Re: Rapiscan AIT System Radiation Survey Reporting

**R-0646-1 Addendum
(Documentation Errors)**

Product Name	Secure 1000SP (Single Pose)
Serial Number	S51003013
Radiation Emission Measurement	Radiation Survey Dated: 05/18/2010
RSO Initials

1. In Beam Dose Measurement: Survey Table. 1

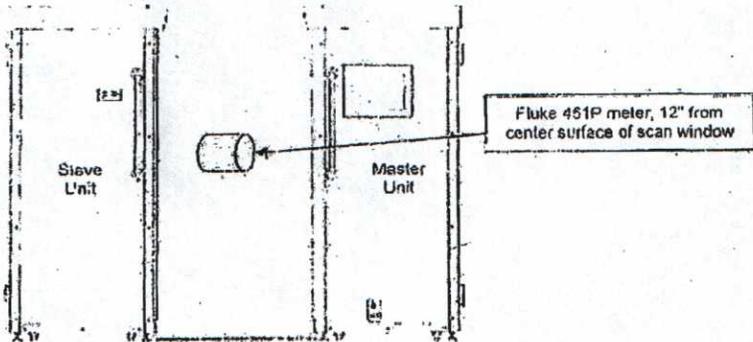
1. TABLE 1: Data in Column 3 for Measured Exposure and Column 6 for Effective Dose. Rapiscan standard operating procedure calls for the technician to use the survey meter in integrated mode. In this case, the Rapiscan technician used the survey meter in dose rate mode. While this mode is not the mode preferred by Rapiscan, it does provide a valid measurement. In this case where this mode was used, the system was found to be below ANSI standard. The added digits after the decimal were a result of averaging, and were not actually observed.
2. Technician noted the system as operating at 12 mA. The current should have been listed as 5mA.
3. Technician did not print his name on survey report.

The service technician should attend refresher training.

The corrected data indicates this system was operating within expected parameters. No re-survey is required for this system.
